Road & Bridge Design Publications

Monthly Update – October 2013

Revisions for the month of **October** are listed and displayed below. The special detail index from the “July Special Update” will remain in effect. Contact Wayne Pikka (pikkaw@michigan.gov) for questions related to the road changes. Contact Vladimir Zokvic (zokvicv@michigan.gov) for questions related to the bridge changes.

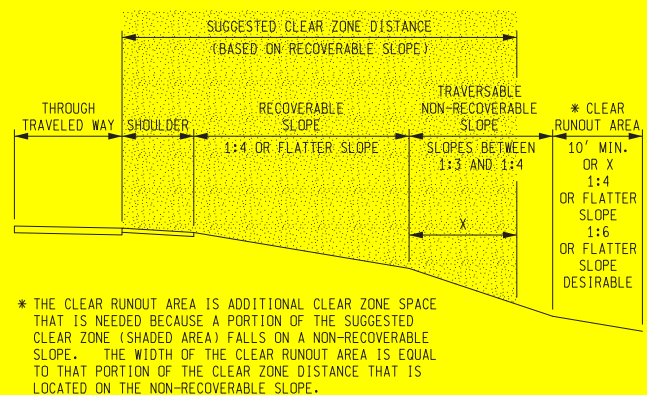
7.01.11A: Obstacles Outside the Calculated Clear Zone: An additional opportunity to improve roadside safety (#4) and accompanying sketch was added.

4. A clear runout area beyond the toe of a traversable (smooth and free of fixed objects) but non-recoverable (between 1:4 and 1:3) foreslope is desirable since vehicles traversing this steep slope are likely to continue to the bottom. The extent of this clear runout area can be determined by subtracting the distance between the edge of traveled way and the breakpoint of recoverable foreslope from the clear zone distance. This distance should be at least 10' if feasible.

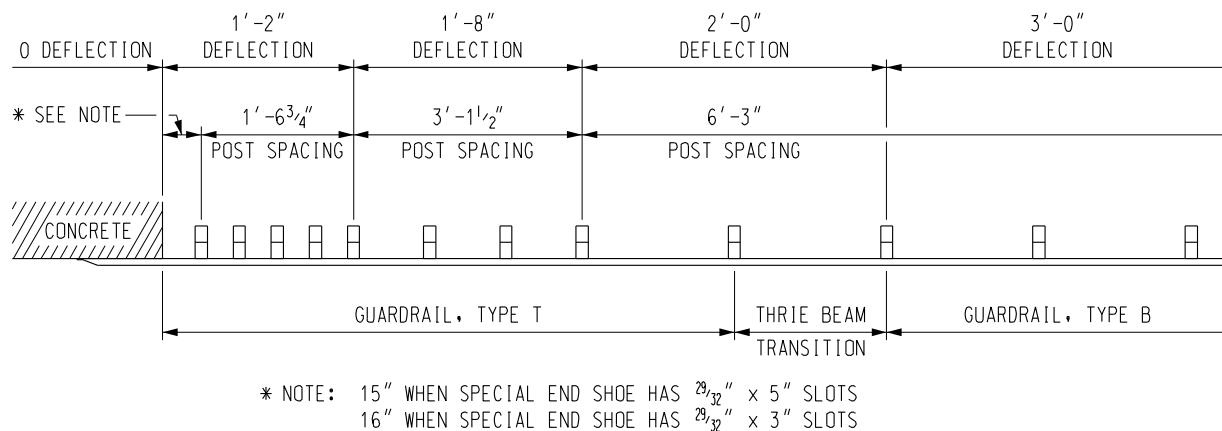
7.01.20: Guardrail Deflection: Revised a reference to the 2011 Roadside Design Guide and added a paragraph on the “Zone of Intrusion”.

The Zone of Intrusion (ZOI) is the region measured above and behind the face of a barrier system where an impacting vehicle or any major part of the system may extend during an impact. For a typical TL-3 system, the ZOI extends between 18" and 30" behind the traffic side face of the barrier. Where practical, the designer should keep objects out of this area. See Section 5.5.2, 2011 AASHTO Roadside Design Guide, for additional ZOI guidance.

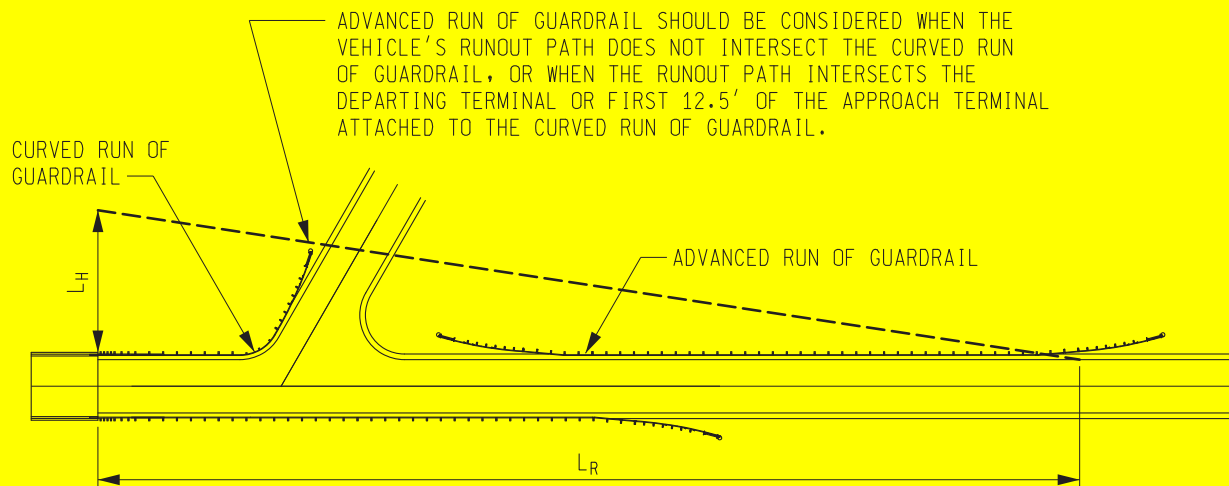
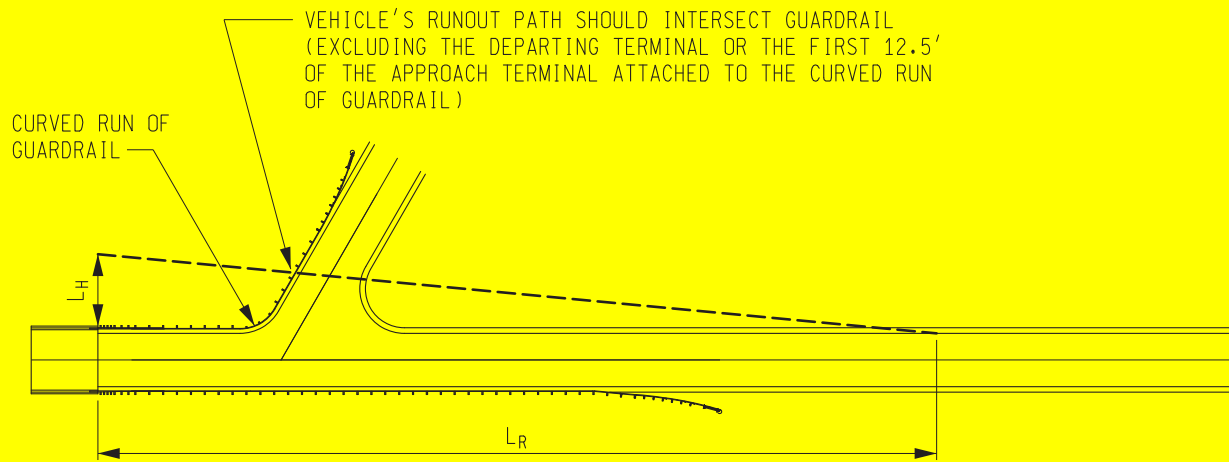
7.01.30H: Guardrail Placed near Intersecting Streets and Driveways: This is a new section dealing with barrier placement when an intersecting street or driveway is located near a roadside object or feature (typically a bridge).

When closing or relocating the intersecting driveway or street is not feasible, two possible solutions are given in the accompanying sketches. A second guardrail run in advance of the intersecting street or driveway should be considered when the vehicle's runout path does not intersect guardrail, or when the runout path intersects the departing terminal or the first 12.5 feet of the approach terminal attached to the curved run of guardrail. See Special Detail 21 for installing a curved guardrail run near an intersecting street or driveway. Also, graphical design methods are suggested when utilizing the proposed solutions depicted in the accompanying sketches.

GUARDRAIL WHEN CURB IS ADJACENT TO
EDGE OF PAVED SHOULDER OR TRAVELED LANE
(DESIGN SPEED 50 mph OR LESS)

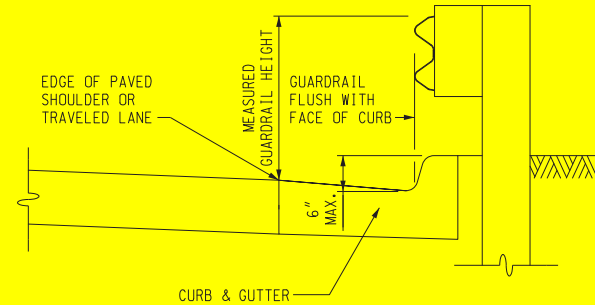
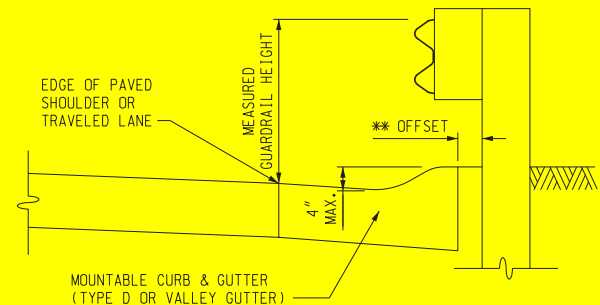
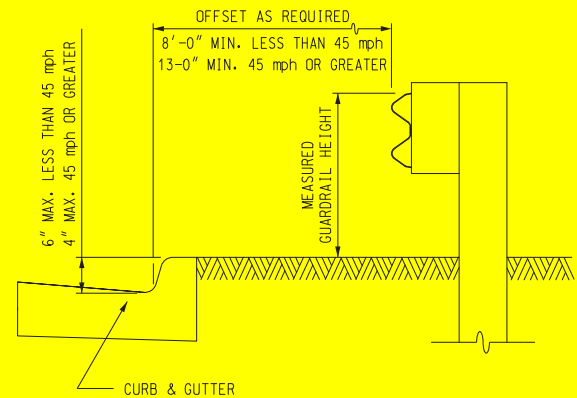
7.01.34: Guardrail in Conjunction with Curb: This section was updated to conform to the 2011 Roadside Design Guide. Revised guidance is given based on the design speed, type of curb, and location of guardrail run.

If guardrail/curb combinations are used when design speeds are less than 45 mph, the curb height should be 6" or less, with the face of guardrail being located either flush with the face of curb or at least 8' behind it.

For design speeds of 45 mph or 50 mph, a 6" curb (or less) may be used if the guardrail is located flush with the face of curb. If an offset from the curb is desired, the curb height should be 4" or less with the guardrail being located at least 13' behind the curb.
